**Re: Exhibition of Vehicle Access and Pedestrian Safety Project (VAPS) at
Sydney Opera House (MP 09-0200)**

**VEHICLE AND PEDESTRIAN SAFETY PROJECT
AT
THE SYDNEY OPERA HOUSE**

RESPONSE TO SUBMISSIONS

Prepared on behalf of
The Sydney Opera House Trust
October 2010

LOADING DOCK 2 - 19m AV TURN PATH

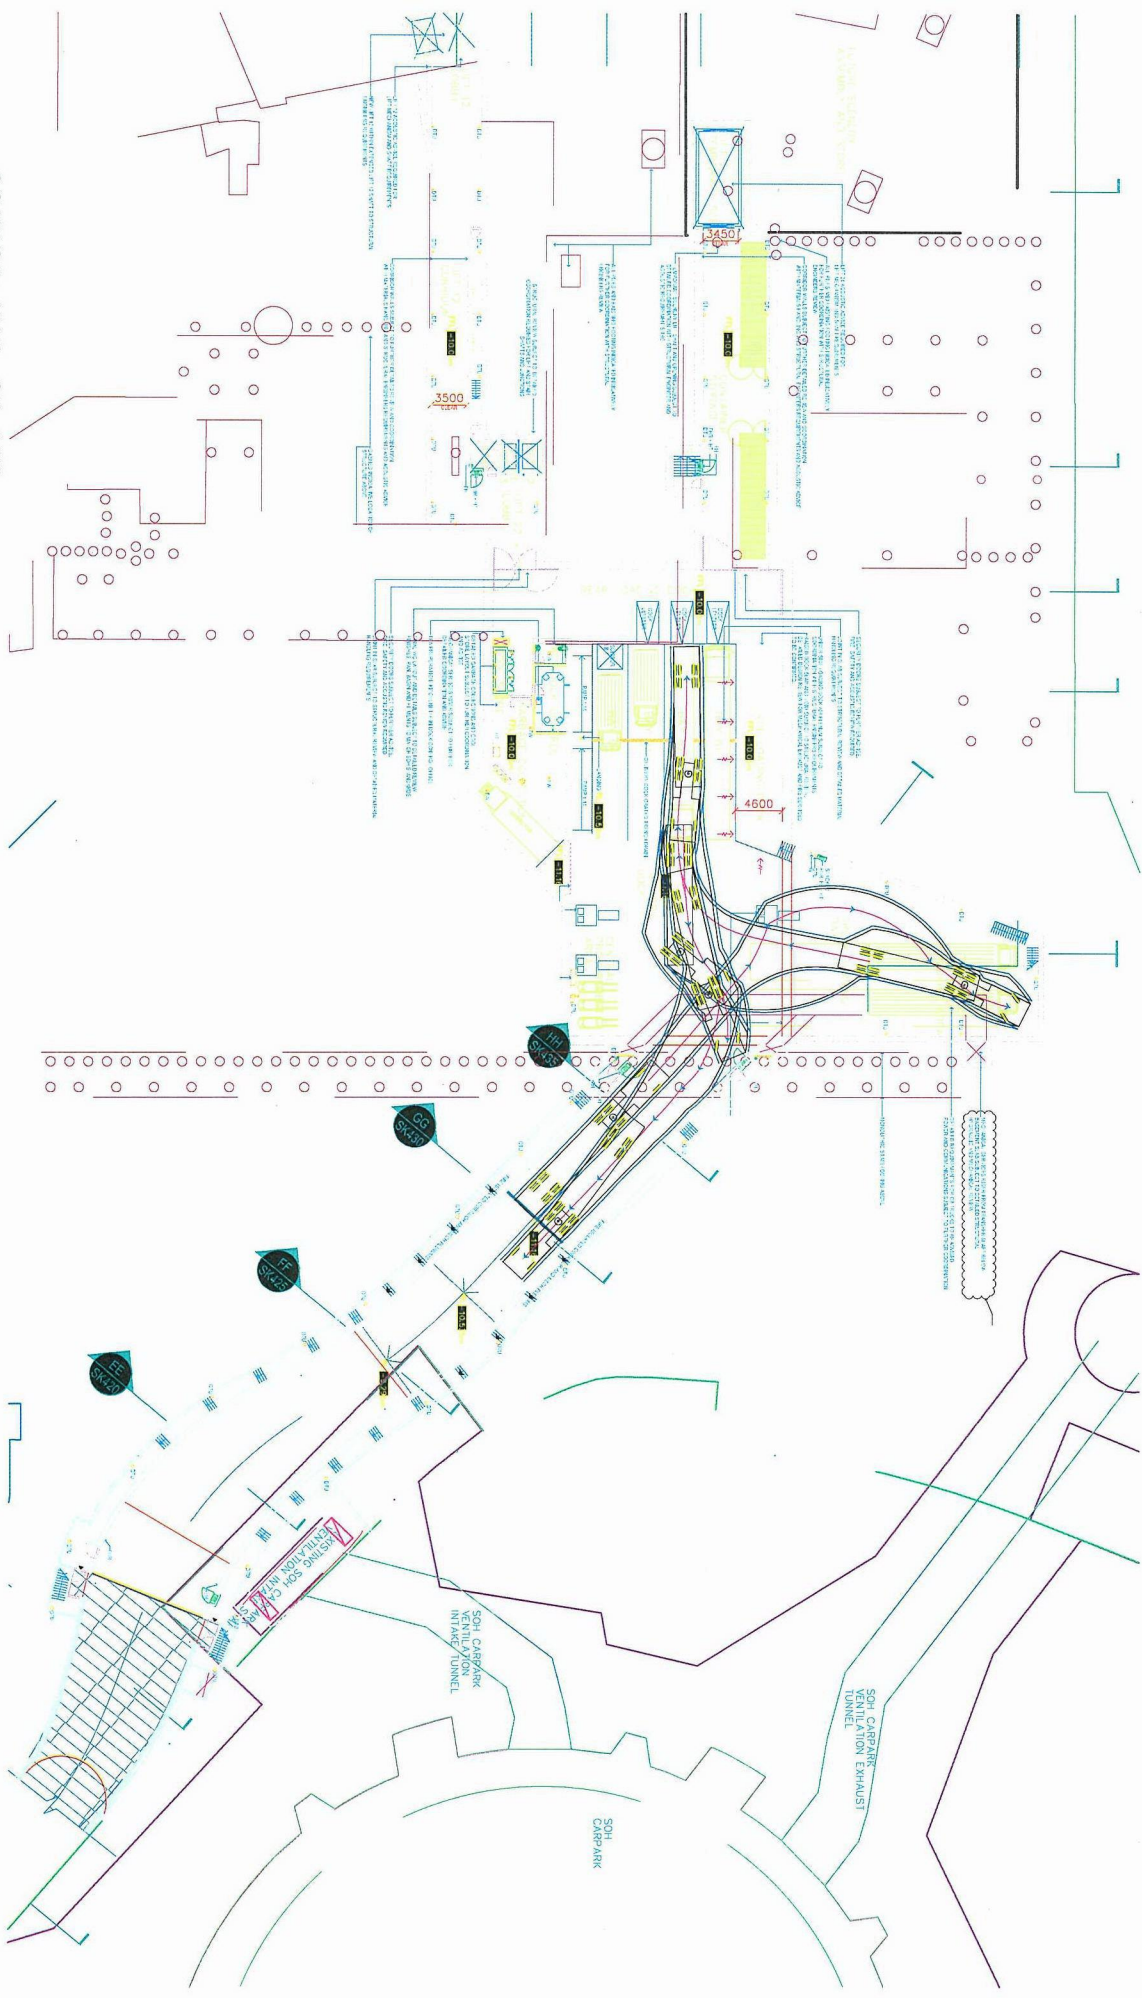
2. The swept path of the longest vehicle entering and exiting the subject site, as well as manoeuvrability through the site, shall be in accordance with AUSTROADS. In this regard, a swept path plan shall be submitted to the Department of Planning for approval, which illustrates that the proposed development complies with this requirement.

The proposal complies with AS 2890.2 – 2002 and a swept paths plan has been provided to demonstrate compliance with AUSTROADS. Refer to statement and plan by Halcrow at **Annexure B**.
